Docket Item # 1 & # 2  
BAR CASE # 2016-0363 &  
2016-0364

BAR Meeting  
December 7, 2016

**ISSUE:** Partial Demolition/Capsulation and Addition/Alterations

**LOCATION:** 412 Wolfe Street

**EX-4**

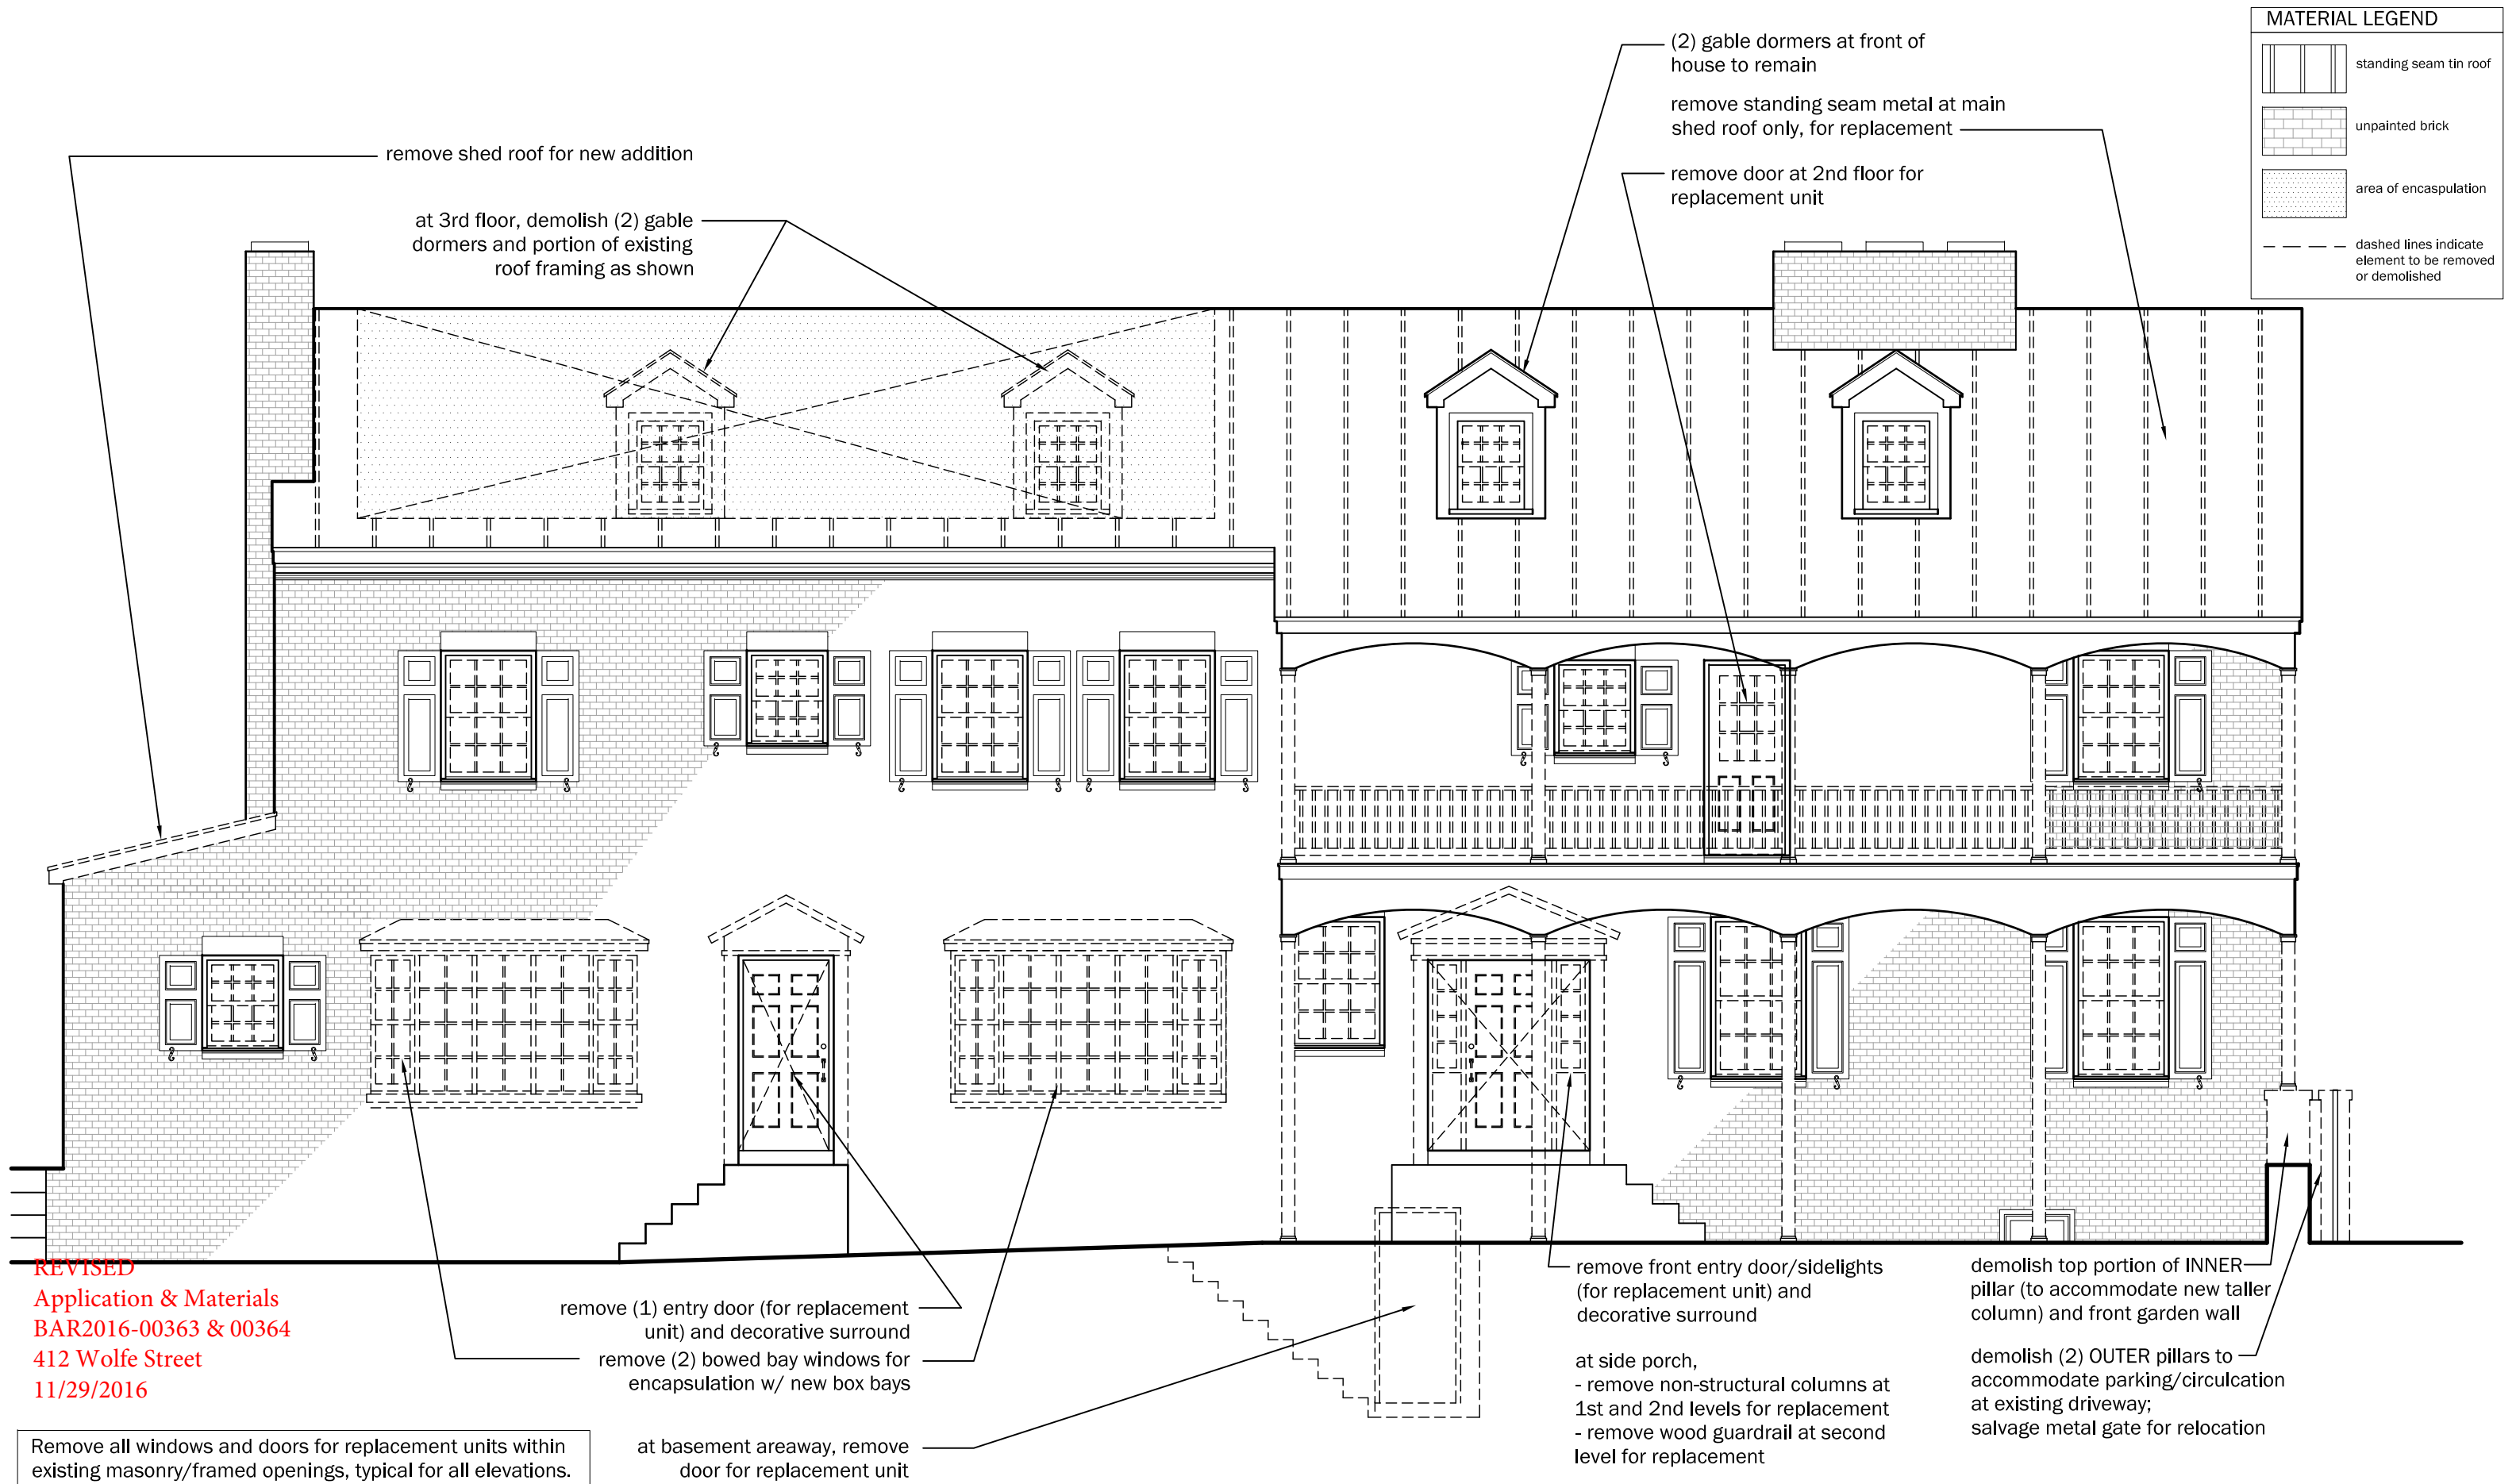
1. Front Entry at Driveway/Existing 2-story Porch:
  - (2) existing OUTER pillars to be demolished to accommodate existing driveway circulation and clearances.

- existing INNER pillar at first post to be lowered to accommodate a new tall decorative column to match all other tall columns on East Elevation.
  - existing front garden wall to be lowered to match existing lowered INNER pillar

- existing metal gate to be relocated from demolished outer pillars to space between first column and existing house.
2. Modified Scope of Work at Back-half of Structure:

- Delete proposed 2-story box bay and First Floor Addition.
  - Existing secondary landing to remain with a new shed roof over existing door.
  - (2) existing bowed bay windows to be replaced with box bays with casement window units.

**A-6**

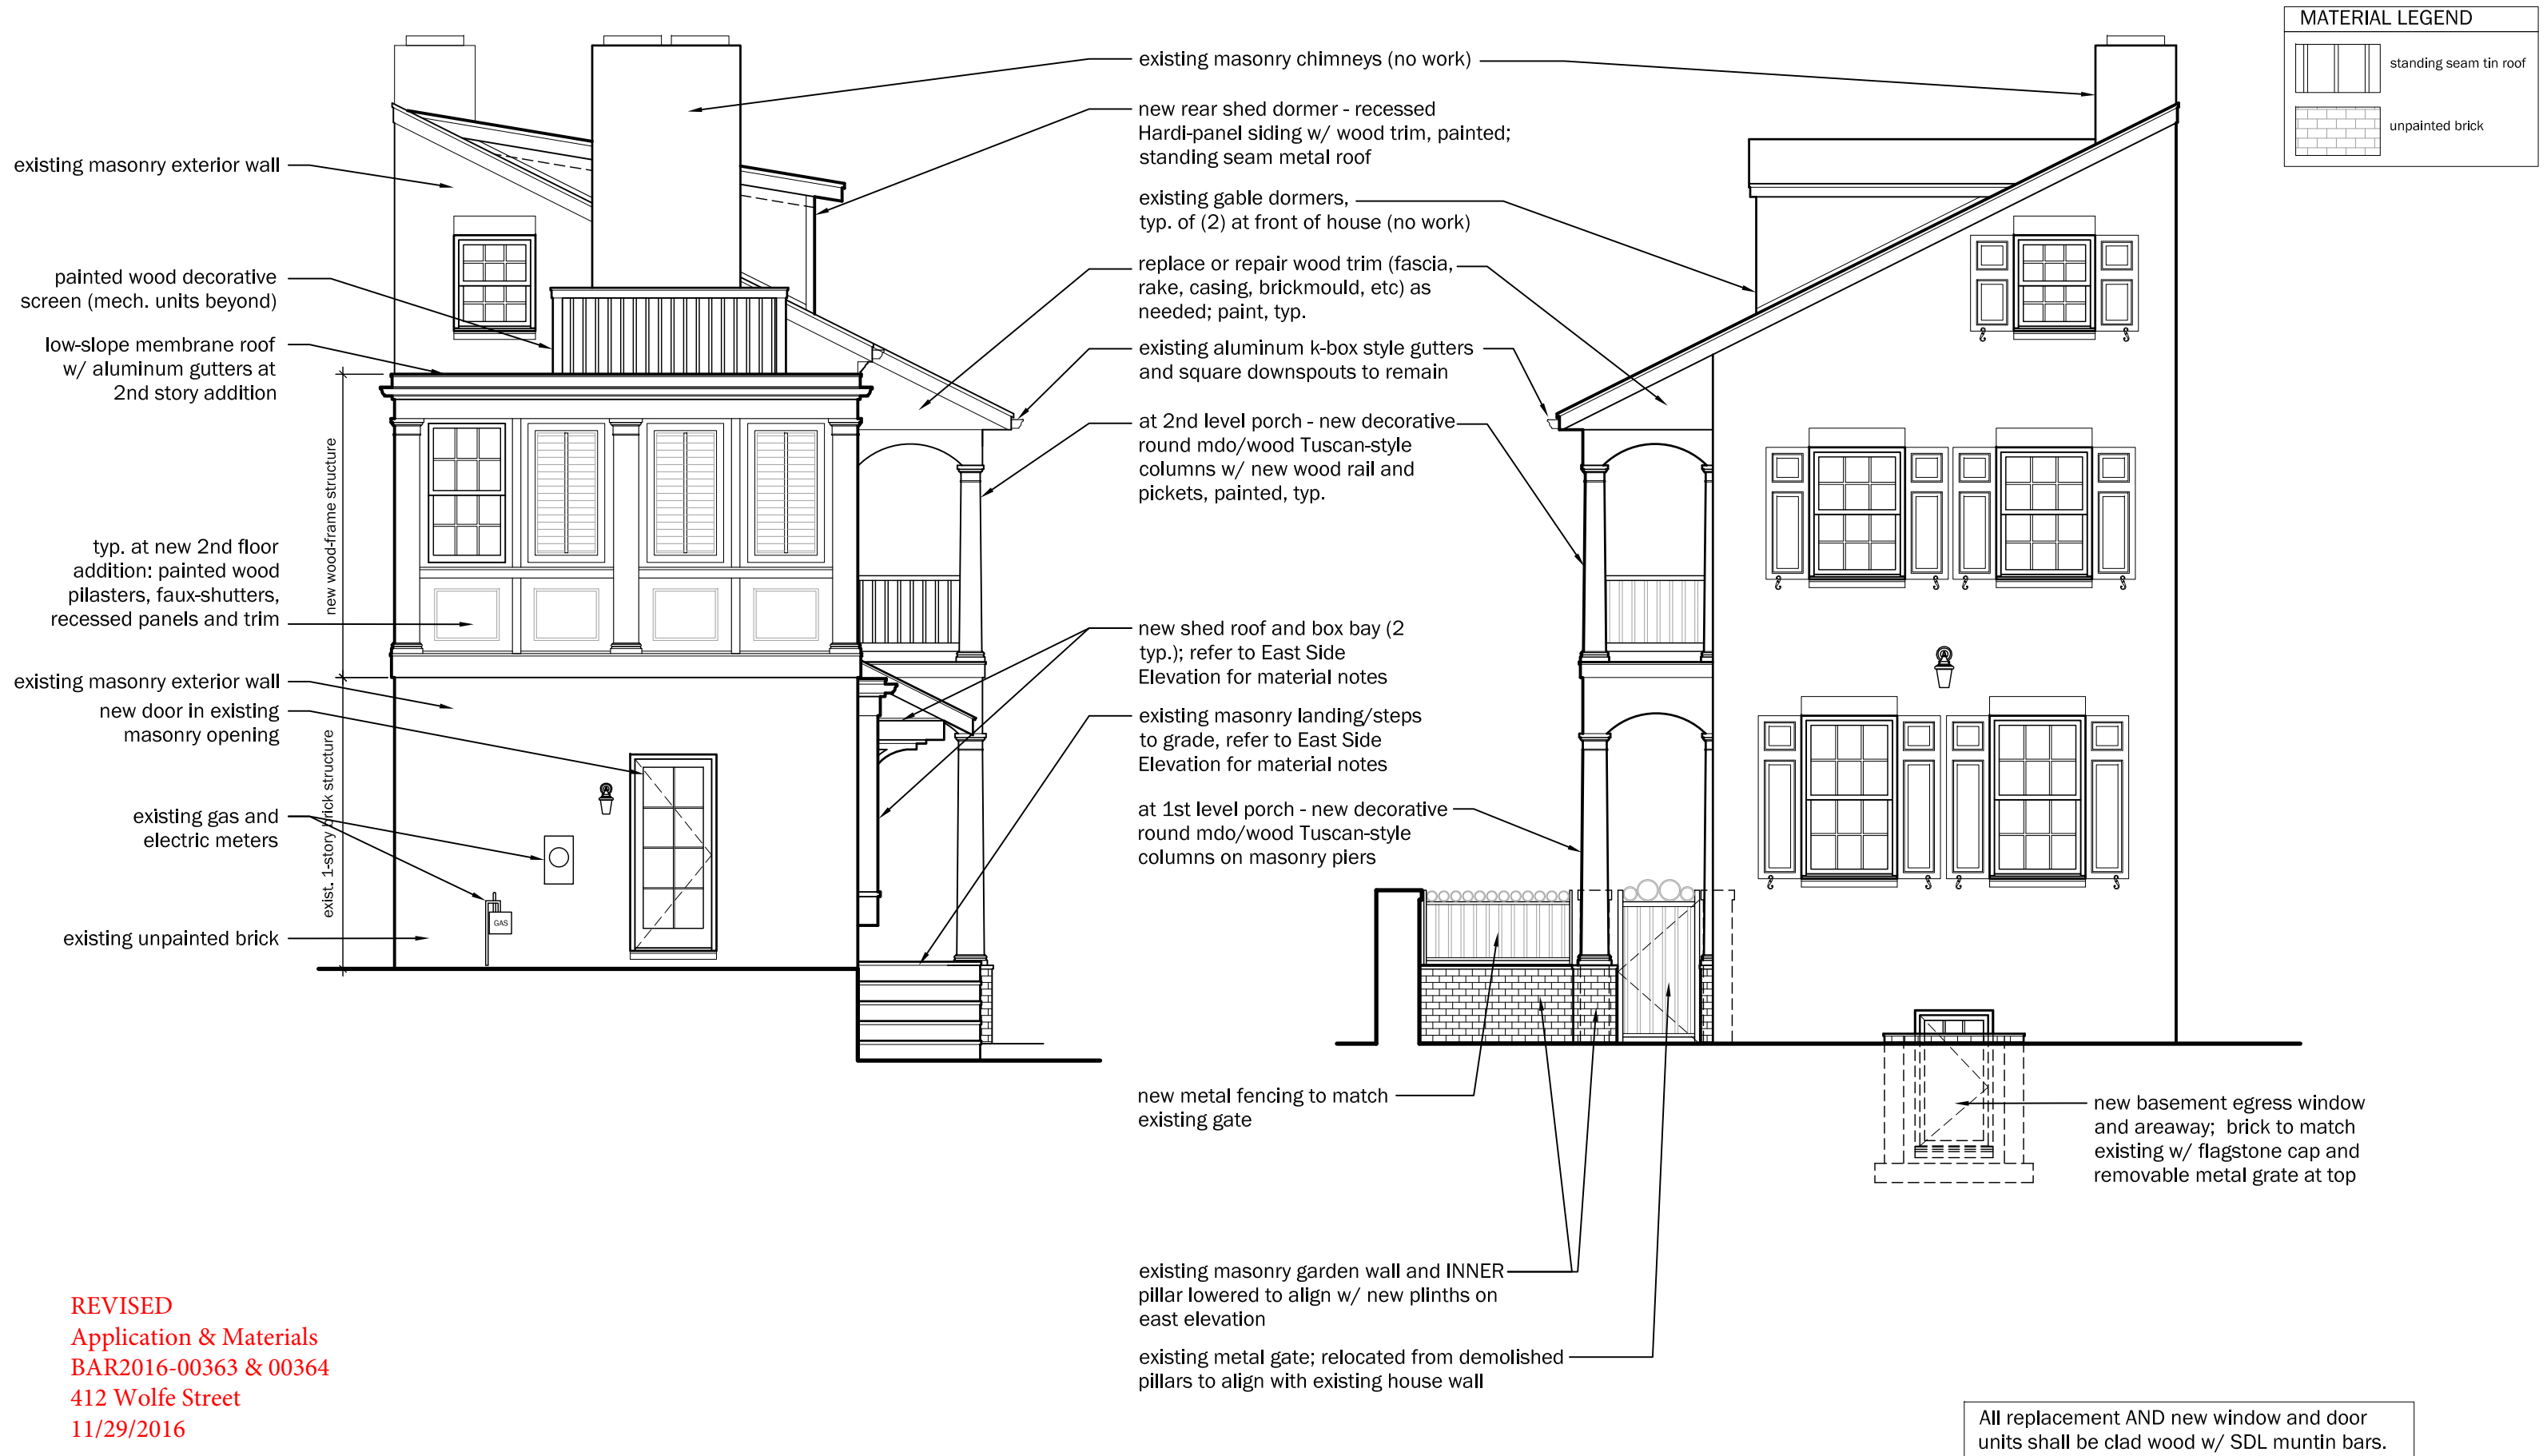
*The Board spent a significant amount of time considering the porch reconstruction and column design, looking at it from both the street (north) elevation and the side (east elevation). The Board was most troubled by the use of different sized columns, particularly on the first floor, due to the two different brick plinth heights. The original plans did not fully illustrate the awkwardness of the current design with two existing brick piers at the front gate in front of the wall, resulting in both inner and outer piers beside each other. The current proposal will demolish the two brick piers (the "outer" piers) and reinstall the gate at the new brick pier of the foremost column. Staff worked with the applicant to study various ways to transition both the gate and successfully reconstruct the two-story porch with new columns. Staff finds that the current scheme mediates the front column's function as both a column in the overall porch design as well as the pier used for the gate. The applicant achieved this by lowering the brick garden wall height to the column plinth height. The garden wall will be altered with the addition of an open metal fence. The existing metal gate will be reused. Staff supports this approach which resolves both the column design and the front approach.*

- Reconfigure two entrance doors, surrounds and stoops on east elevation
- Reconstruct existing two-story porch with new columns and railings. *New first floor columns (all same size and height) to be placed on low brick plinths constructed at same height of lowered front garden wall.*

- *Remove upper portion of front garden wall and install simple metal fence atop brick kneewall.*
- ~~Construct two-story cantilevered box bay on east elevation~~
